**CONSTRUCTION OF A METAL STRUCTURE AT POST OFFICE
PORT MATHURIN, RODRIGUES
Bid No: MRA/OAB/METALSTRUCTURE/105/25**

**ADDENDUM No. 2
Issued on 18 July 2025**

ANNEX A2

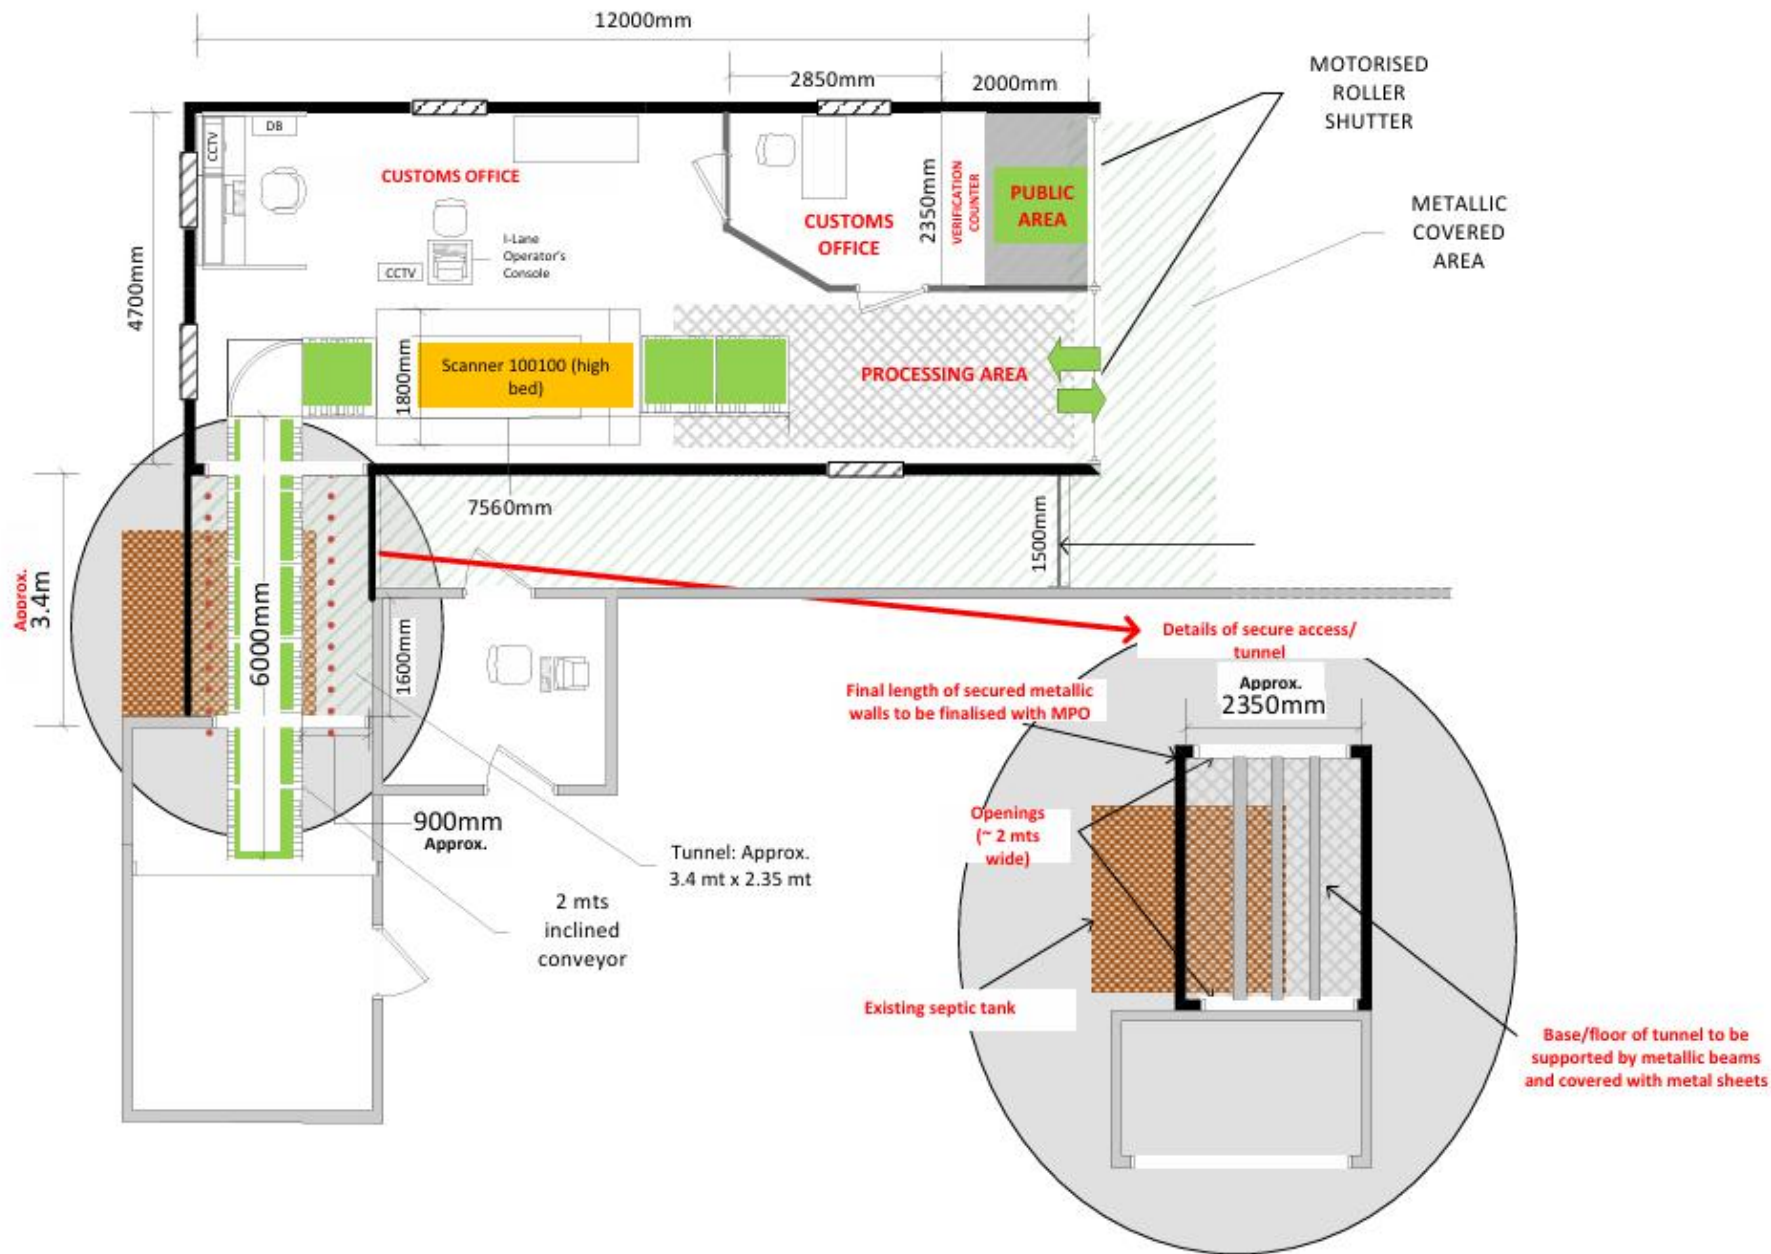
6	Design and Erect an Inclined Galvanised Metal Roof Structure with zincalume metal sheet covering minimum 0.6mm thick to corridor between new and existing building (indicated in green stripes as per Annex A1) - refer to table 3 in schedule of requirements.	Lot	1		
7	Design and Build of a covered tunnel with sloping pitched roof (3250 mm x 2350 mm), height to be aligned and linked with the existing post office building to the new office metal structure in galvanized metal structure and zincalume metal sheet covering minimum 0.6mm thick (refer to Annex A2 & A3).	Lot	1		
8	Air Curtains: Supply, Delivery and Installation, Testing and Commissioning of Air Curtains (dimension to fit opening size) as indicated in Annex B .	Nos.	3		
9	Window Openings: Supply, Delivery and	Nos.	3

ANNEX A3

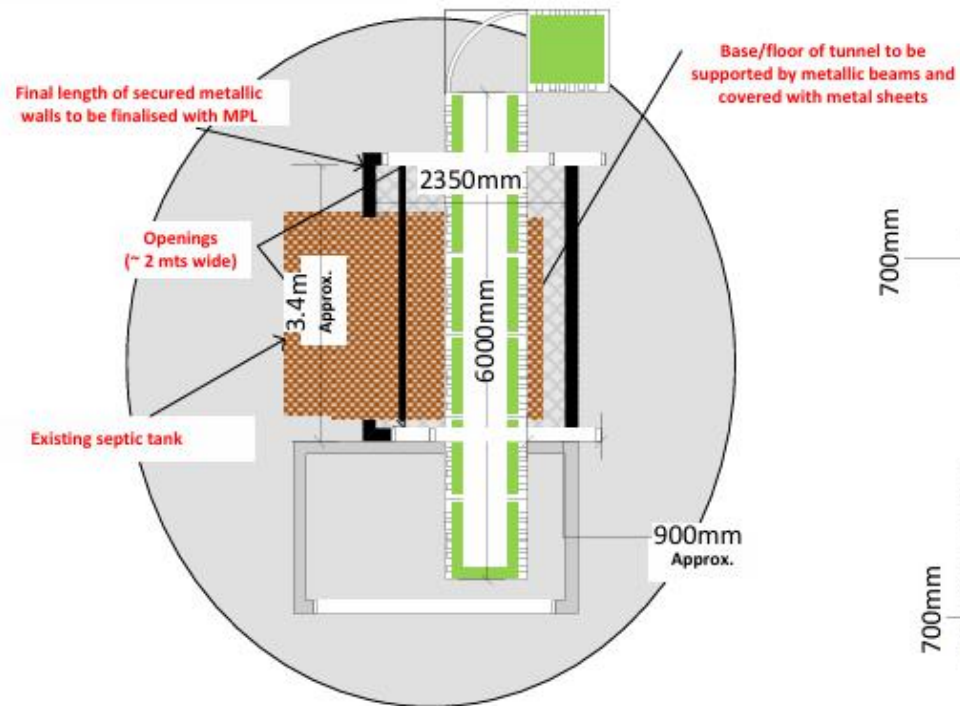
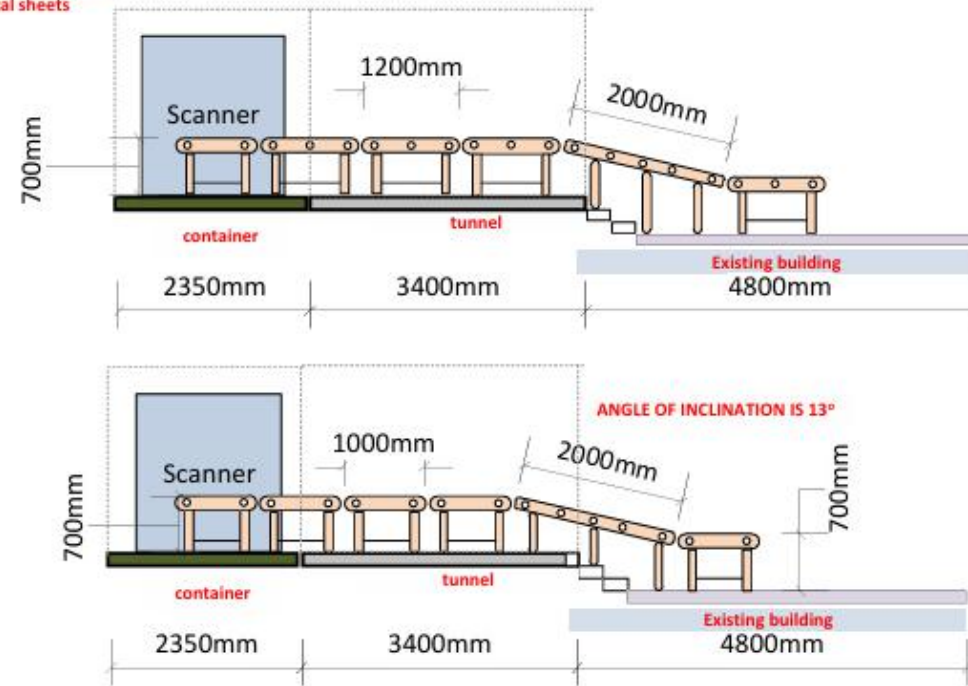
- 3. A tunnel to link the existing post office building to the new metallic structure (refer to **Annexures A1, A2 and A3**). The tunnel should be able to accommodate motorized conveyor belts of 600 kilos (kg);

- 4. A covered inclined metal structure for the corridor between the existing building and the new metallic structure (**refer to Annexes A1, A2 and A3**);

ANNEX B

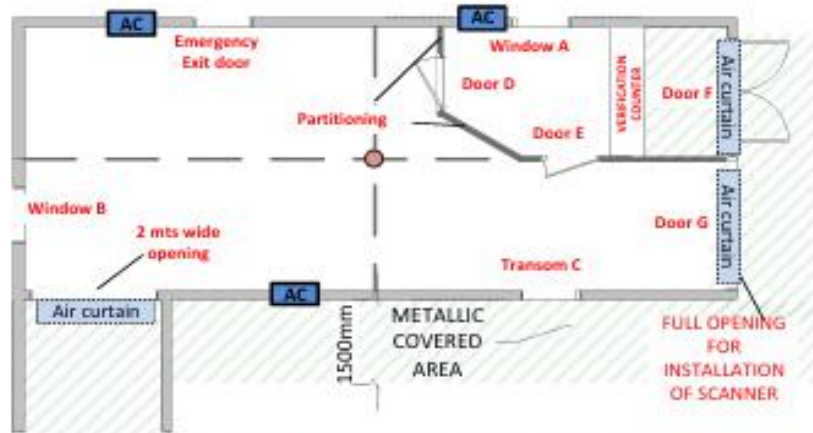
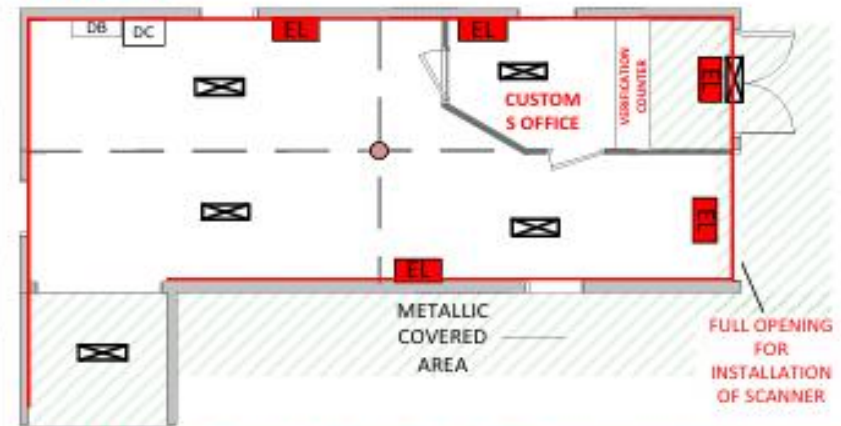
- 1. Wall claddings, windows, transom, doors, exit doors, painted surfaces as per client request, office flooring, partitioning for one office in accordance with the Mauritius Fire Services (refer to **Annex B**);

ANNEX D

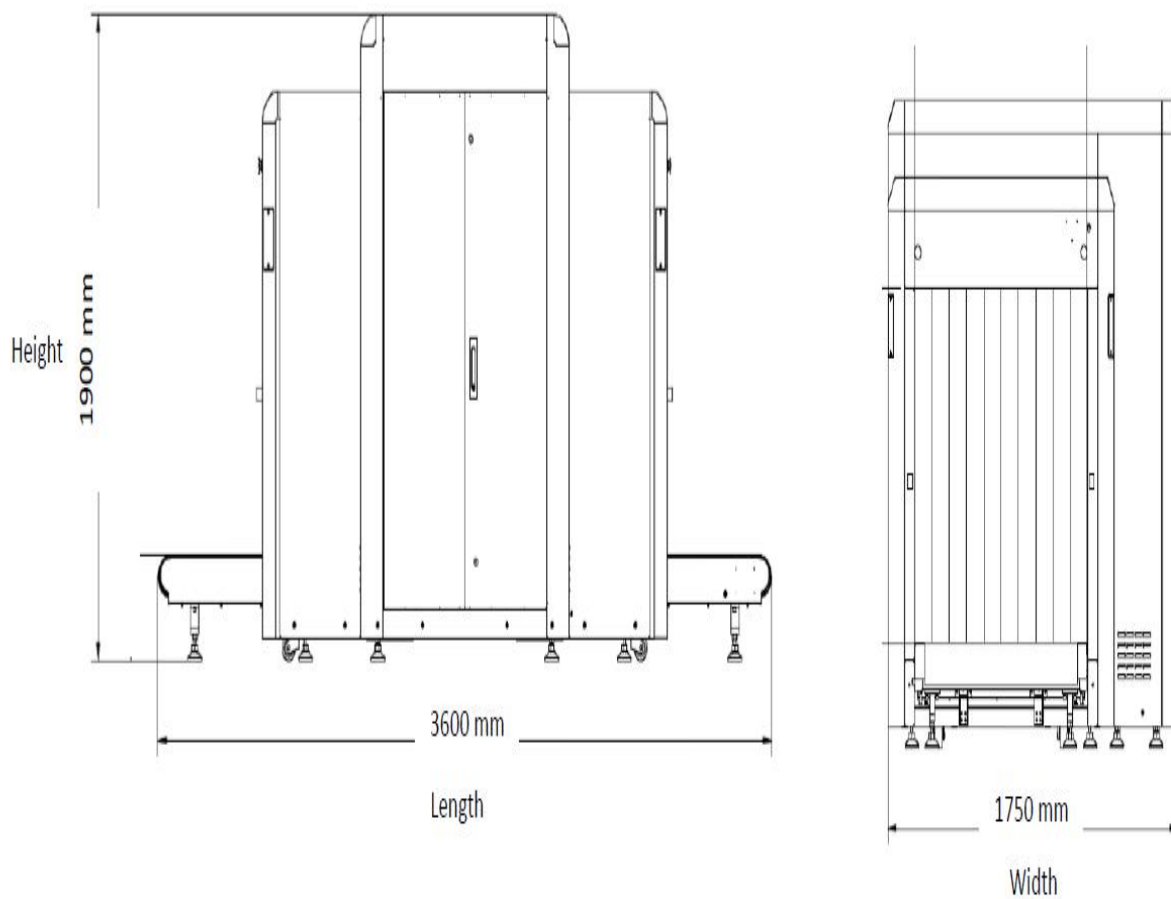
The Mauritius Revenue Authority intends to install one X-ray scanner (**Annex D**) at the Post Office in Port Mathurin, Rodrigues, in a secured compound. Given the topology and the landscaping of the site (behind the existing post office), it is proposed to construct a metallic structure on a concrete platform.

Weight to be considered is approximately 3000 kilograms
